REPORT BY THE CHURCH ENVIRONMENT COMMISSION ON ST RITA PRIORY SITE PROJECT

The report refers to development application PA10598/17 for a development on St Rita Priory site which is owned by the Augustinian Order (henceforth referred to as the Order). The application for the development was submitted by Bay Street Hotel Complex Limited (henceforth referred to as the Applicant).

Annex 2

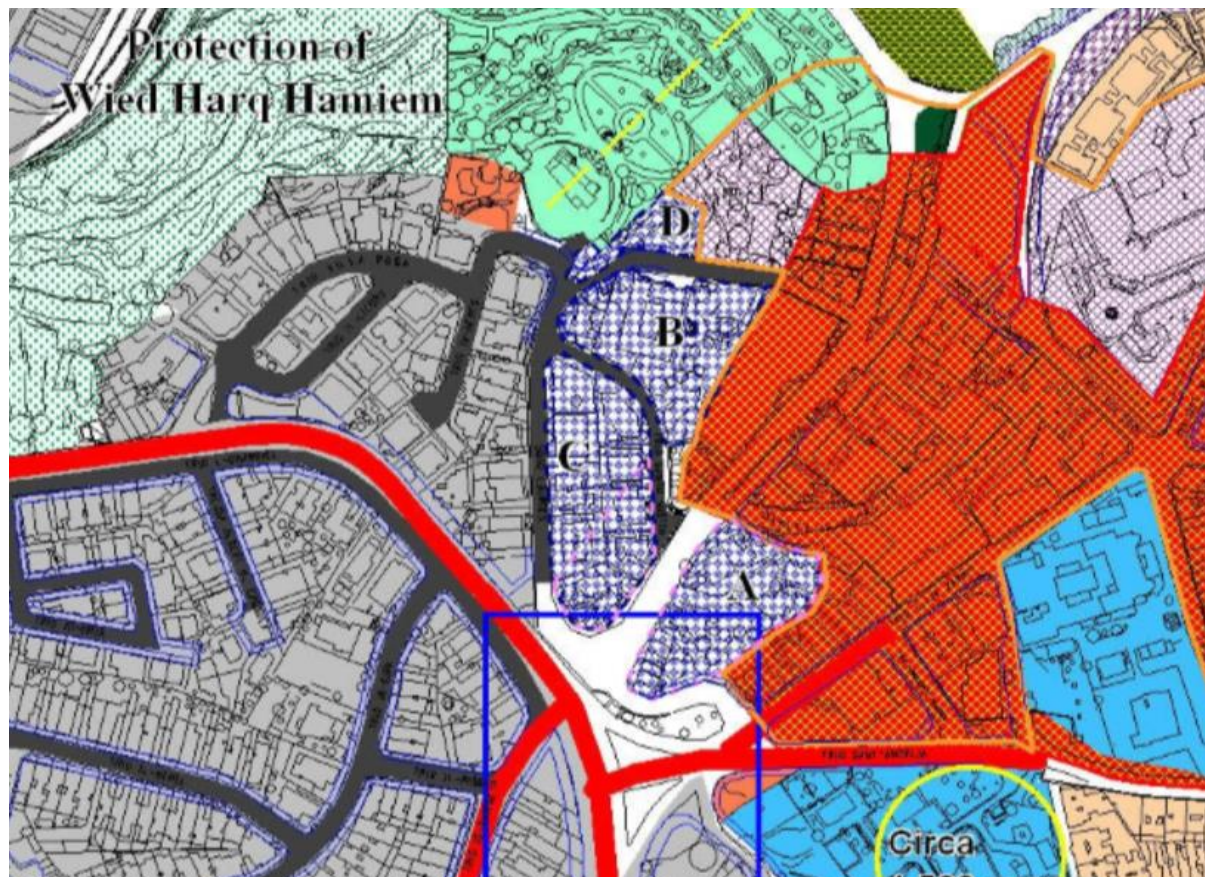
4. The applicant's Project Description Statement (Annex 2) gives a justification for the application of the FAR ratio policy based on the provision of an open space in front of the historic structure and an improved pedestrian experience. In terms of justification this is substantially inadequate. Moreover, computation for the four parameters are required to determine the maximum height of building that would be permitted. If such a computation has been prepared by the applicant, it does not seem to be publicly available.

Annex 6

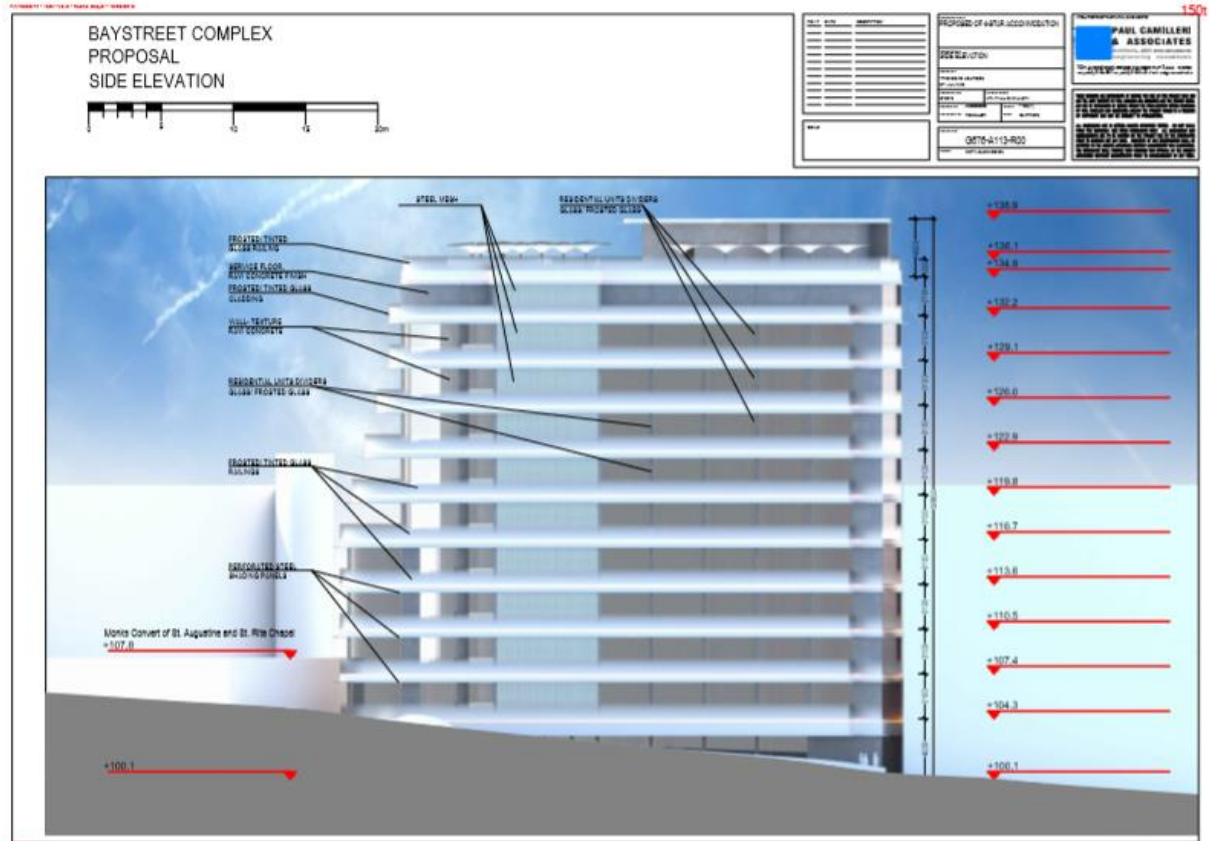
1. The development is contrary to the Floor Area Ratio policy;
2. The site is not amenable to the development of a tall building (i.e. a building higher than 10 floors).
3. A twelve-storey façade overlooking Upper Triq Santu Wistin is excessive, and badly impinges on nearby residents and users of the street (see Annex 6).
4. The proposed twelve-storey building is excessively close to the priory which is a scheduled Grade 2 building.

Annex 8

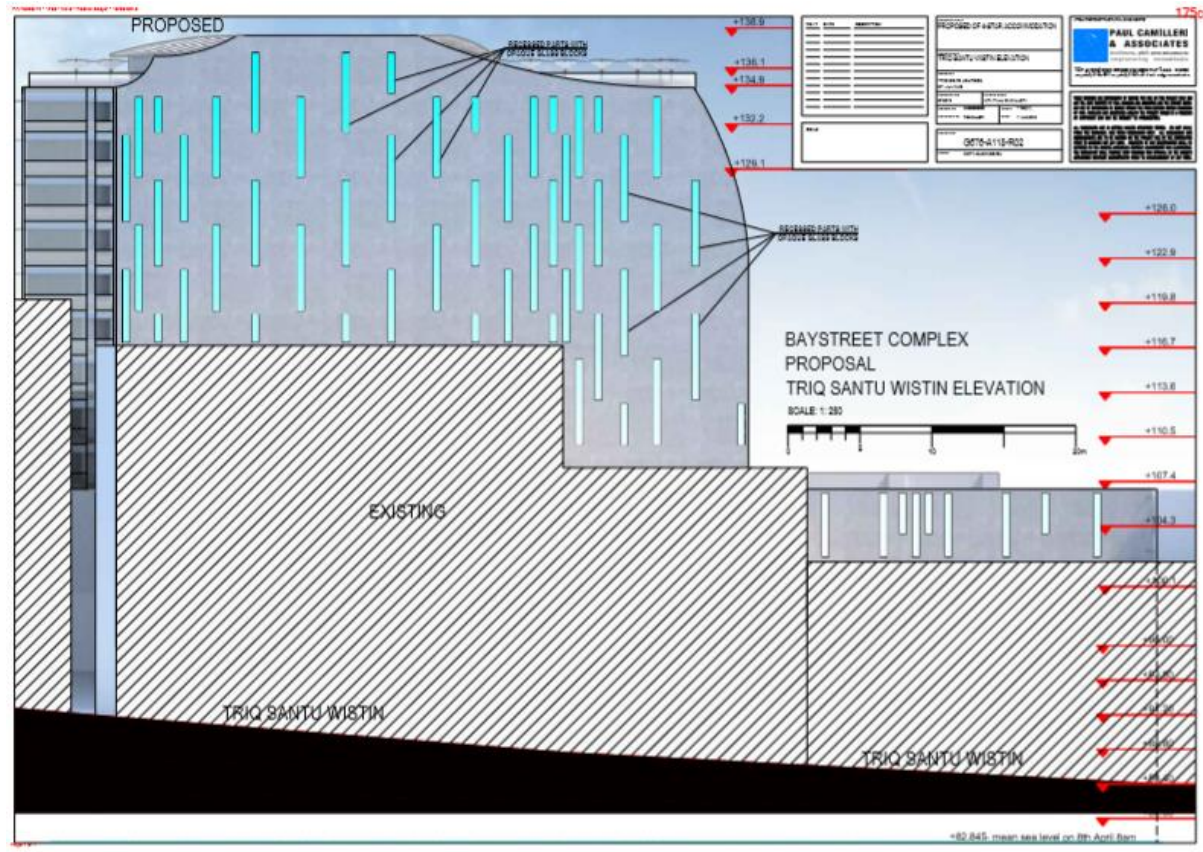
planned streets, irrespective of the land area of the site”. If anything, the proposed development demonstrates why the FAR policy is only allowed for a completely detached block. If permitted, the proposed development would give rise to a blank party wall of an area of 870 m², with a height ranging from 6 to 8.5 floors (18 to 25.5m) (see Annex 8).

4. For new developments, party walls are to be avoided. Large areas of blank wall are unsightly and degrade the visual aspect of the streetscape. In many cases, it cannot be avoided where a building is designed in accordance with the height limitation. However, that is not the case here. The site under consideration can be developed without creating large areas of blank party walls. In terms of urban design quality, the large party wall is a strong argument against allowing a tall building on this site.
